## CHANGE ORDER

Record No.: 9-PR-0014-9-FO-0001-4-RC-0155

Title: **Cancel insert yellow silicon tube at part process**

Apply for 16MPO connector of AFL product

**Before**

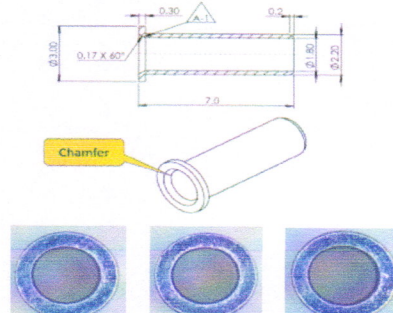
FOV propose to cancel insert yellow silicon tube inside pintube at part process:

- The sharp edge of the original pintube can make scratch on the fiber buffer
- So, we apply the silicon tube inserted inside the pintube to help to prevent damage fiber when insert pintube into cord.

Changed new Pintube version with chamfered edges--&gt; risk to damage fiber is low

So, we propose to cancel operation insert yellow silicon tube to reduce cycle time

## ANEX 01: Evaluate apperance of fiber after insert pin tube

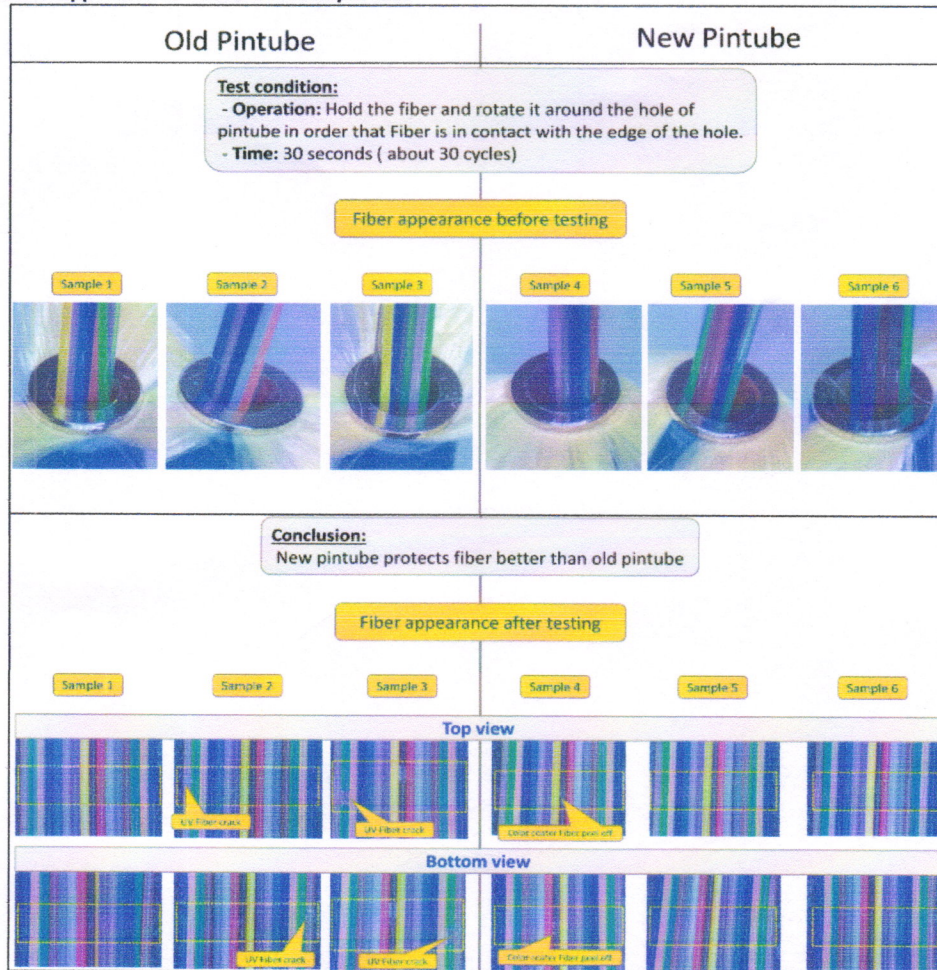
- New pintube protects fiber better than old pintube. Refer Anex 01
- Ratio defect fiber broken outside due to pin tuber reduce after using new pintube. Refer Anex 02
- Reduce the cycle time at process ~6s/MT connector
- Cost saving ~60.65 USD/month as below:
